AGENDA
CITY OF LAKE WORTH BEACH
HISTORIC RESOURCES PRESERVATION BOARD REGULAR MEETING
CITY HALL COMMISSION CHAMBER
WEDNESDAY, SEPTEMBER 15, 2021 -- 6:00 PM

MEMORANDUM DATE: September 8, 2021

RE: **220 South L Street**

TITLE: **HRPB Project Number 21-00100216:** A Certificate of Appropriateness (COA) for the construction of a new ± 540 square foot accessory dwelling unit located at 220 South L Street; PCN #38-43-44-21-15-091-0070. The subject property is located in the Low-Density Multi-Family Residential (MF-20) zoning district and is a contributing resource to the Southeast Lucerne Local Historic District.

Staff Recommended Options

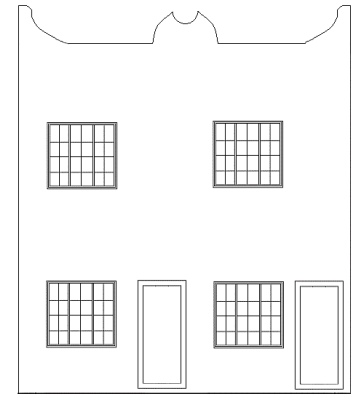
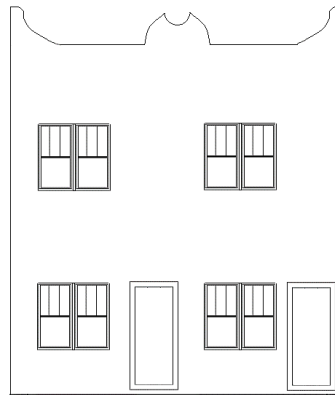
Proposed Window Replacement
*Utilizes horizontally-oriented
single-hung windows*

As discussed in the property development history, the openings on the front façade received approval in 2001. Therefore, these openings and can be replaced in-kind by the property owner although it is not the *most successful* approach to replicating original windows in a Mission Revival structure.

Utilizes paired single-hung windows separated by a mullion or a triplet of casement windows/horizontal rollers (equal thirds configuration)
